R	U.S. Department of the Interior BUREAU OF LAND MANAGEMENT		Sundry Print Report 06/25/2024
	Well Name: GLENN-RYAN	Well Location: T26S / R37E / SEC 13 / NWSW / 32.041428 / -103.123547	County or Parish/State: LEA / NM
	Well Number: 21	Type of Well: INJECTION - ENHANCED RECOVERY	Allottee or Tribe Name:
	Lease Number: NMNM7951	Unit or CA Name:	Unit or CA Number:
	US Well Number: 3002525856	Operator: OXY USA INCORPORATED

Sundry ID: 2785826

Type of Action: Plug and Abandonment Time Sundry Submitted: 12:27

Permanent Abandonment of Federal Wells Conditions of Approval

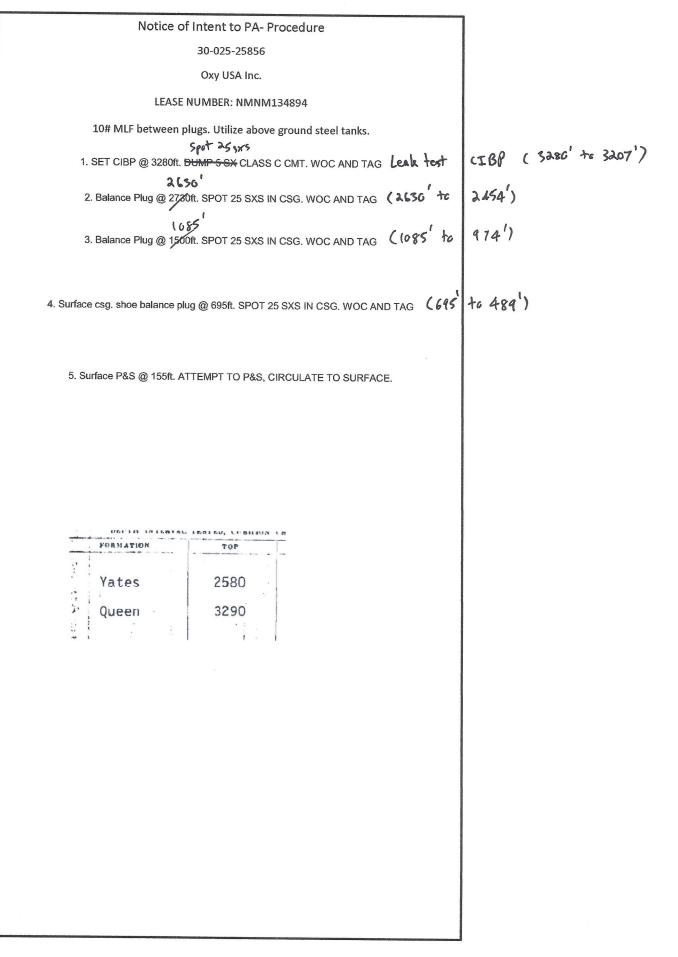
Sundry ID	2785826						
						Cement	
Plug Type	Тор	Bottom	Length	Tag	Sacks	Class	Notes
							Perf and attempt
							squeeze from 155'
Surface Plug	0.00	100.00	100.00	Tag/Verify	25.00	С	to surface. Verify
							Spot cement from
							695' to 489'. WOC

8.625 inch- Shoe Plug	489.55	595.00	105.45	Tag/Verify	25.00	С	and Tag.
							Spot cement from
							1085' to 974'. WOC
Top of Salt @ 1035	974.65	1085.00	110.35	Tag/Verify	25.00	С	and Tag.
Base of Salt @ 2530	2454.70	2580.00	125.30	Tag/Verify			
<u>Yates @ 2580</u>	2504.20	2630.00	125.80	If solid base no need to Tag (CIBP present and/or Mechanic al Integrity Test), If Perf & Sqz then Tag, Leak Test all CIBP if no Open Perforatio ns	25.00	с	Spot cement from 2630' to 2454'. WOC and Tag.
				need to Tag (CIBP present and/or Mechanic al Integrity Test), If Perf & Sqz then Tag, Leak Test all			
Queen @ 3290	3207.10	3340.00	132.90	CIBP if no Open Perforatio

If solid base no			
				need to Tag (CIBP present			
				and/or Mechanic al Integrity			
				Test), lf Perf & Sqz then Tag, Leak			
				Test all CIBP if no Open Perforatio			Set CIBP at 3280'. Leak test CIBP.
CIBP Plug	3245.00	3280.00			25.00	С	Spot cement from 3280' to 3207'.
Perforations Plug (If No CIBP)	3280.00	3464.00	184.00	Tag/Verify			
5.5 inch- Shoe Plug	3499.15	3635.00	135.85	Tag/Verify

CONDITIONS		
Created By	Condition	Condition Date
loren.diede	Notify NMOCD 24 hours prior to beginning P&A operations.	7/31/2024
loren.diede	Run CBL after setting CIBP @ 3280'. Submit CBL to NMOCD via E Permitting.	7/31/2024
loren.diede	Extend the Top of Salt plug to 900' to cover the Rustler formation top. Rustler formation top picked at 950'.	7/31/2024
